RE: SDR-12949 - SITE DEVELOPMENT PLAN REVIEW

CITY OF LAS VEGAS
FIRE STATION NO. 48
SITE PLAN

SHEET C-3
3 OF 26 SHTS
CLV DWG. NO.

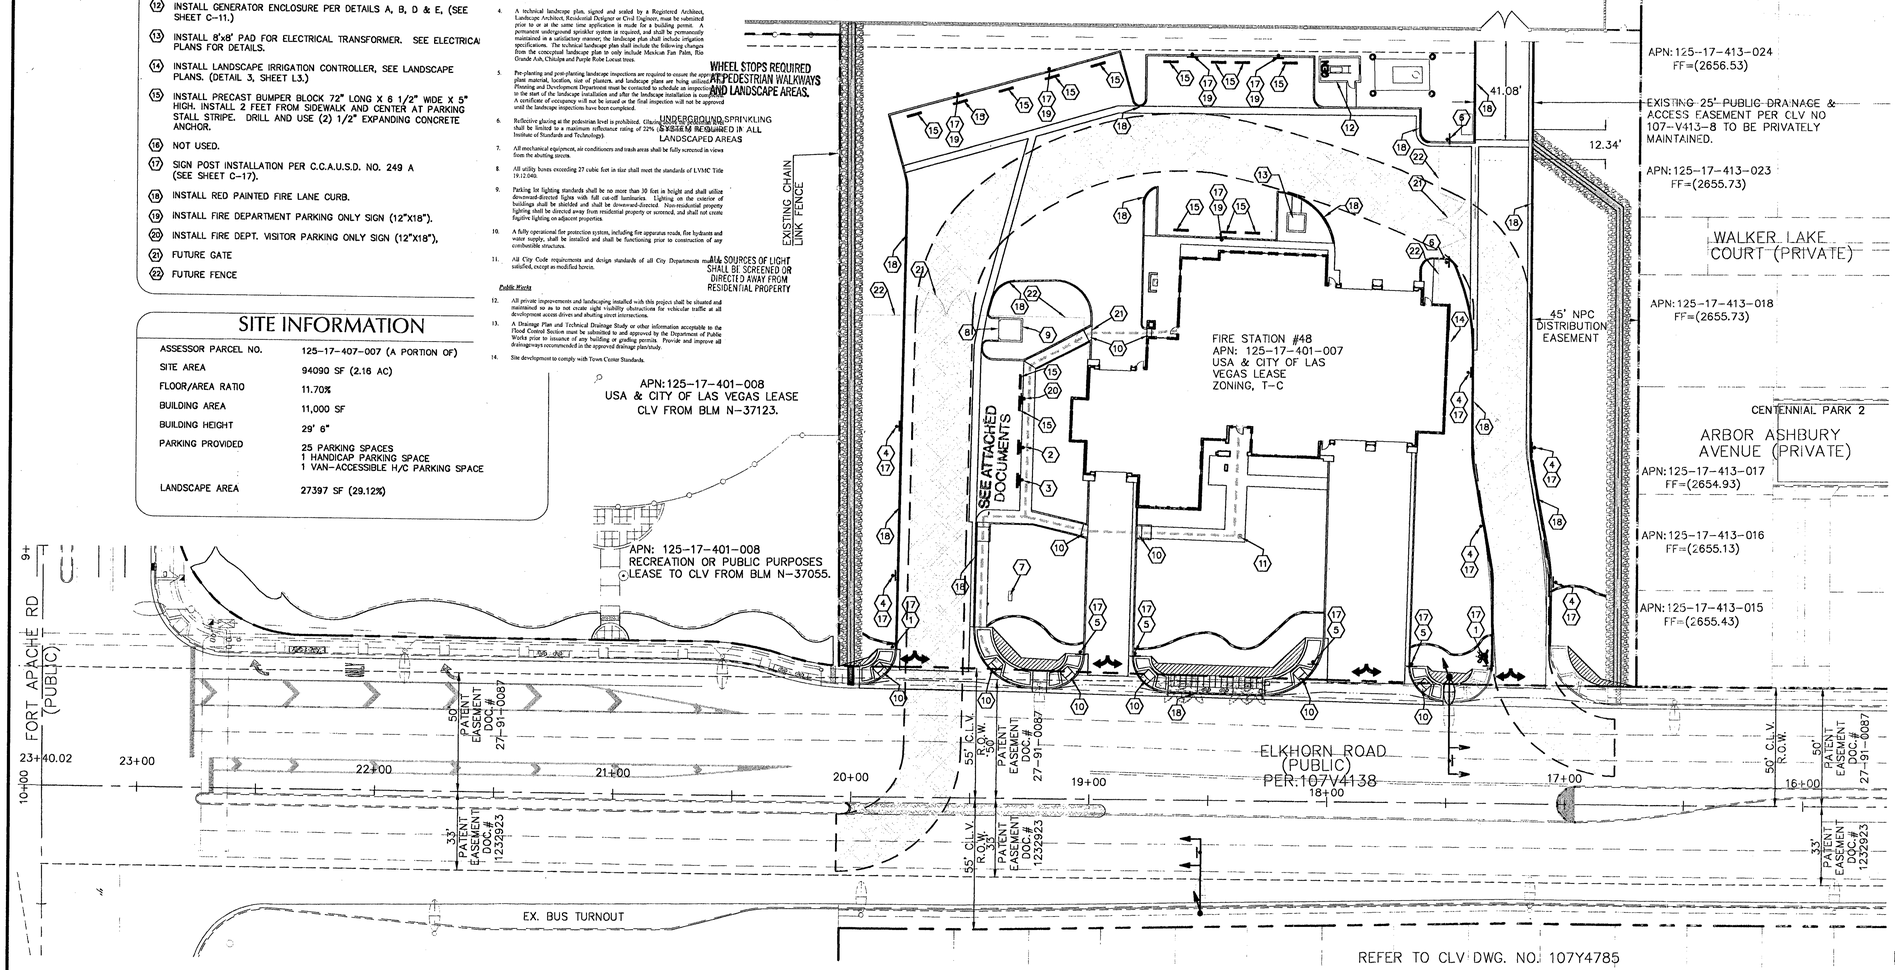
The Planning Commission voted to *APPROVE* your request, subject to the following:

2. All development shall be in conformance with the site plan, landscape plan, and building elevations, date stamped 08/14/07, except as amended by conditions herein.

3. A Waiver from Town Center Streetscape Standards is hereby approved, to allow a zero foot amenity zone, no trees, and no special pavement and sidewalk treatment.

7. All mechanical equipment, air conditioners and trash areas shall be fully screened in views from the abutting streets.
8. All utility boxes exceeding 27 cubic feet in size shall meet the standards of LVMC Title 19.12.040.

9. Parking lot lighting standards shall be no more than 30 feet in height and shall utilize downward-directed fights with full cut-off luminaries. Lighting on the exterior of buildings shall be shielded and shall be downward-directed. Non-residential property lighting shall be directed away from residential property or screened, and shall not create fugitive lighting on adjacent properties.

10. A fully operational fire protection system, including fire apparatus roads, fire hydrants and water supply, shall be installed and shall be functioning prior to construction of any combustible structures.

12. All private improvements and landscaping installed with this project shall be situated and maintained so as to not create sight visibility obstructions for vehicular traffic at all development access drives and abutting street intersections.
13. A Drainage Plan and Technical Drainage Study or other information acceptable to the Flood Control Section must be submitted to and approved by the Department of Public Works prior to issuance of any building or grading permits. Provide and improve all drainageways recommended in the approved drainage plan/study.
14. Site development to comply with Town Center Standards.

WHEEL STOPS REQUIRED AT PEDESTRIAN WALKWAYS AND LANDSCAPE AREAS.

UNDERGROUND SPRINKLING SYSTEM REQUIRED IN ALL LANDSCAPED AREAS

ALL SOURCES OF LIGHT SHALL BE SCREENED OR DIRECTED AWAY FROM RESIDENTIAL PROPERTY

BUILD AS PER RED-LINES AND/OR ATTACHED CLV DESIGN
OR
PROVIDE COMPLETE REVISIONS
